**STANNAH LIFTS LTD****ELECTRICAL TECHNICAL BULLETIN**

Date : 26/04/06
Product : Midilift SL
Subject : Introduction of new pump units
Status : Option introduced
Page : 1 of 2

MIDLIFT SL - PUMP UNIT CONNECTION DETAILS

DRAWING NO: **9444/5**

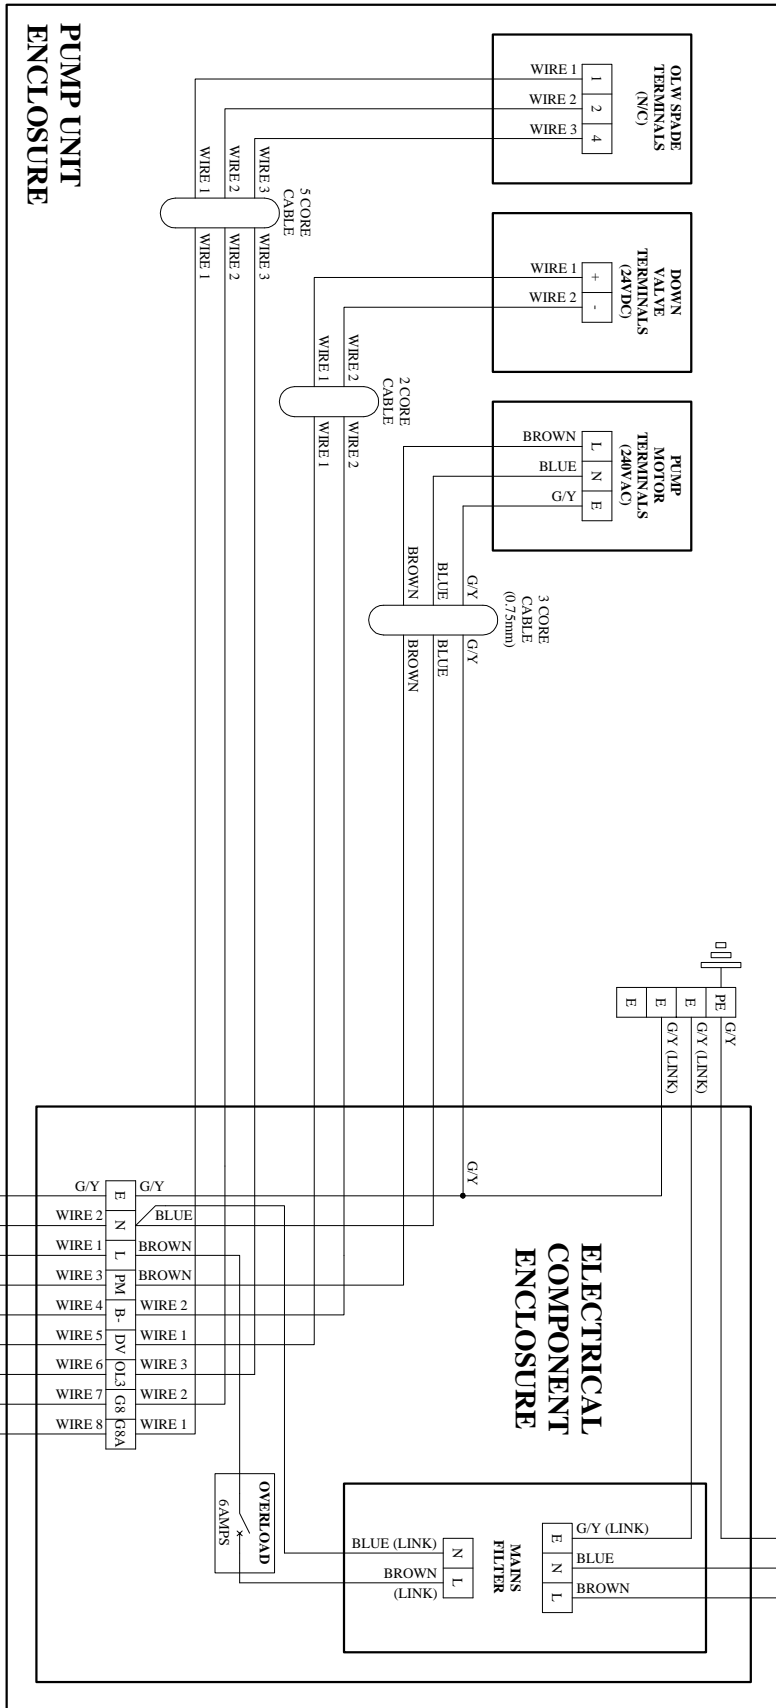
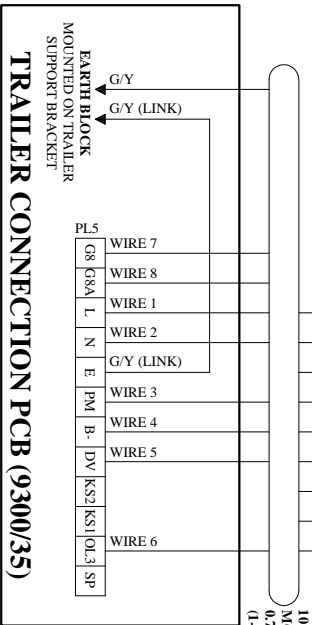
Although the new pump will perform the same as the previous unit, there is an alteration to the electrical connections to the trailer PCB. The pump motor cable has changed from 12 to 10 cores, with the termination of the individual numbered wires also changing.

EV G: MOTOR CABLE CHANGED TO 10 CORE. G8A, G8, & OL3 NUMERS CHANGED. 23/03/06 DG
EV F: TRAILER CABLE REMOVED AND EARTH BONDING NOTICE ADDED 25/04/05 MH
EV E: TRAILER CABLE LABELLED 'CABLE 1' 05/09/03 MH
EV D: OLW INDICATOR CONNECTION DETAILS ALTERED TO SUIT COMMUNICATION OPTIONS 03/02/03 MH
EV C: SPARE TRAILER WIRES IDENTIFIED 11/11/02 MH
EV B: TERMINATIONS ALTERED TO MATCH TRAILER PCB AND OVERLOAD INDICATION 12/08/02 MH
EV A: CARRIAGE ISOLATION SWITCH TERMINALS ALTERED 02/07/02 MH

Therefore, it is important that during this transition period, the type of pump unit is identified and that the appropriate wiring diagram is used to carry out the electrical terminations – do not wire from memory.

The wiring manual is currently being revised to issue 6 and will contain connection details for both pump units. However, until it has been issued, an uncontrolled drawing will be included in the wiring manual sent with every contract (a copy of which has also been attached to this document).
